City of Parramatta	
File No:	DA/823/2022

SECTION 4.15 ASSESSMENT REPORT
Environmental Planning & Assessment Act 1979

DA No:	DA/823/2022
Subject Property:	Lot 14 DP 939772, 62 Boundary Street, Parramatta
Proposal:	Demolition of existing structures, tree removal and construction of a 3 storey, 48 place childcare centre with basement parking for 12 vehicles.
Date of receipt:	20 October 2022
Applicant:	Baini Design
Owner:	E Nehme
Property owned by a Council employee or Councillor:	The site is not known to be owned by a Council employee or Councillor
Political donations/gifts disclosed:	None disclosed on the application form
Submissions received:	10 submissions received within the notification period and 1 submission received outside of the notification period.
Recommendation:	Refusal
Assessment Officer:	Denise Fernandez

Figure 2: Site Plan. Source: BainiDesign.

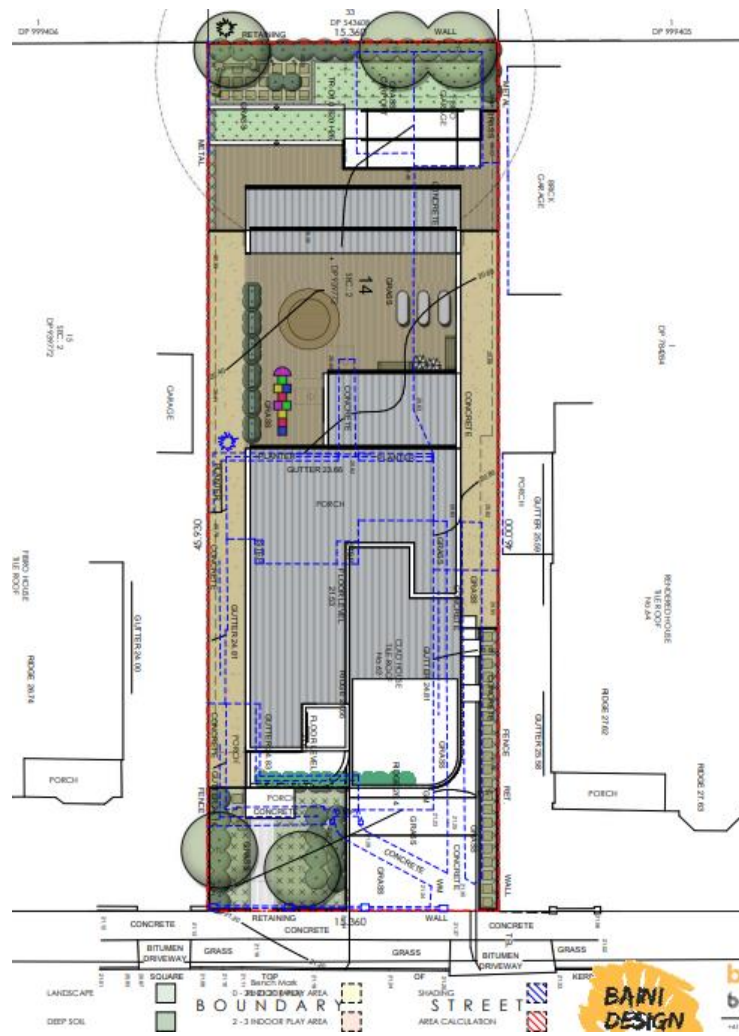
2. The proposed three-storey form combined with the very small side boundary setbacks results in a development that is too dense for the site and its context.

3. The proposed 2m side boundary setbacks are less than half of the 4.5m setbacks that are required by the DCP.
4. The basement extending from side boundary to side boundary prevents inclusion of deep soil areas and tree planting at the sides.

7. The blank western side elevation is inappropriate, both in terms of environmental performance and appearance.
8. The driveway/basement entry takes up half the frontage width and this constrains landscape screening which is generally lacking.

11. The submitted architectural drawings of the development lack detail. The elevations are too sketchy and perspectives showing the building within its context are lacking.

14. The street elevation drawings do not appear to show the correct cross fall along the street – the drawings show a fall which appears greater than actually exists.
